Interactive comment on "Bayesian performance evaluation of evapotranspiration models for an arid region in northwestern China" *by* Guoxiao Wei et al.

Responds to the comments: Referee #1: General comments: 1. Response to comment: For the objective (1), what is the purpose of selecting the best model using BME, to improve model prediction? If the purpose is to improve model prediction, did the authors try Bayesian model averaging? Based on the results, some models are underestimate, some models are overestimate, it is possible that model averaging could give a better prediction performance. Response: We believe this comment is very important for considerably improve our manuscript. Our original idea was to identify which model is optimal for ET prediction, and then to improve the model with the Bayesian

Fig. 1.

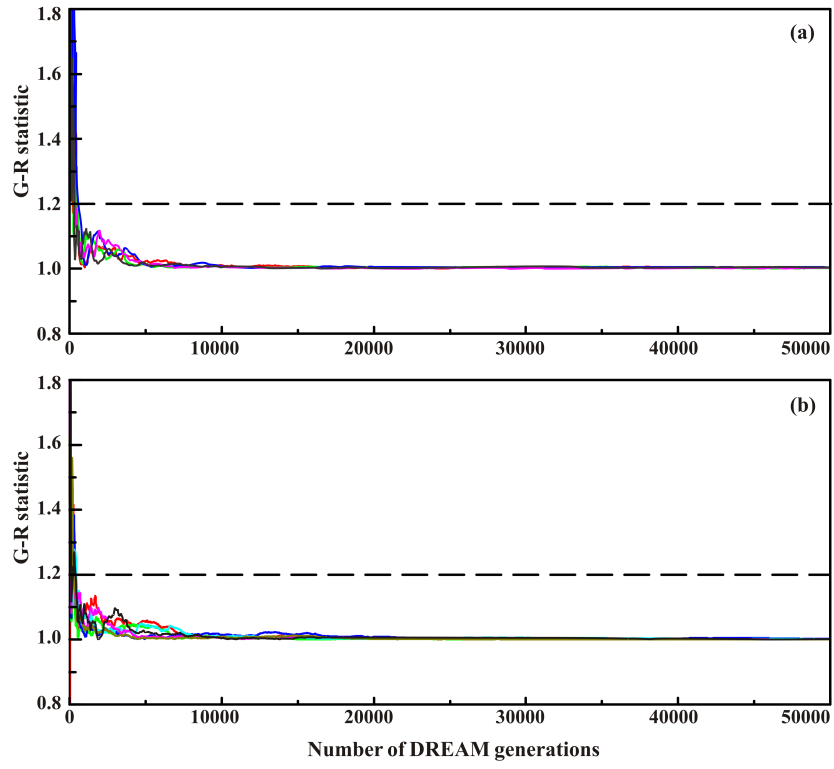
6. Response to comment: Line 280-282, based on Figure 1, DREAM needs far less than 8000 generations to make the GR statistic smaller than 1.2. Also, based on Figure 1's x-axis scale, it is hard to tell "obviously" the chain converged after about 620 and 450 generations. Response: Thanks for the comments. We decided to change the sentence "DREAM needs far less than 8000 generations to make the GR statistic smaller than 1.2 for the both models " to "The algorithm needs about 8,000 generations to make the G-R statistic close to 1.0 for the both models." In addition, we will delete the statement "Obviously, the complete mixing of the different chains and convergence of DREAM were attained after about 620 and 450 generations for PM and SW models, respectively".

7. Response to comment: Figure 1. In Figure 1(b) the position of the dash line is not at 1.2. The position of the label (b) is not aligned well with the label (a). Response: Thanks for the comment. We will redraw the Figure 1. This can see in the modified Figure 1 .

Fig. 2.

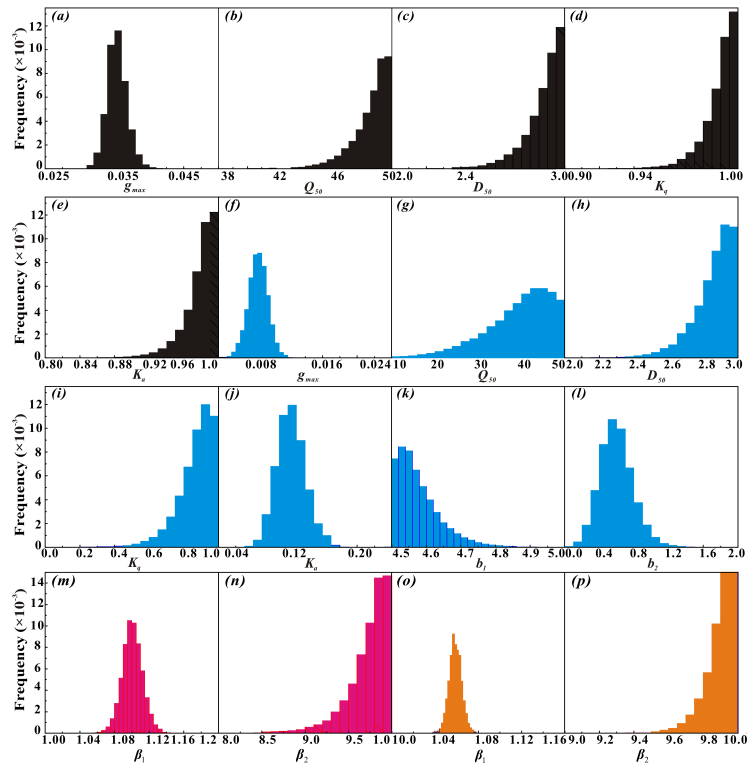
8. Response to comment: Figure 2. If the authors cannot get more information from the CDFs than the histograms, I suggest deleting the CDFs which make Figure 2 busy and confusing. Also, I would like to see more discussion about Figure 2; what insights the

9. Response to comment: Line294-297, I found the discussion of the figure 2 is confusing. I think, the figure 2 says the histograms tend to concentrate in the upper bounds, not the lower bounds. Also, the authors should increase the upper limits of these parameters not decrease, because the histograms are concentrated in the upper bounds. Response: Thanks for the comment. We will revise this sentence.

authors can obtain from these plots? Response: Thanks for the comment. We have redraw the Figure 2 as in the attached file. The main insights summarized as following: gs and modeled ET in PM model are relatively insensitive to Q50, D50 and Kq. Hence, these parameters could not be well constrained. The calculation of in SW model is the same as in PM model, and thus, and modeled ET for SW model are also insensitive to parameters of Q50, D50, Kq. Therefore, these three parameters were also not be well constrained in SW model. In addition, for edge-hitting parameters, their uncertainties may be also the outcome of model biases or EC-measured ET data errors. Although the ecophysiological parameter gmax is a variable in the equation in both PM and SW models, but this parameter is sensitive to and has large influences on the evaluated ET. Its effect is relatively independent compared to the other meteorological parameters in the models, and therefore this parameter was well specified in SW model. The parameter Ka is insensitive to gs and modeled ET. In contrast, Ka is contained in equation of net radiation flux into the substrate (Eq.12) in SW model. From the above analysis, we could see that Ka not only involved the distribution of energy between the canopy and the soil surface but also the energy imbalance. Therefore, parameter Ka has a great influence on the performance of the SW model.
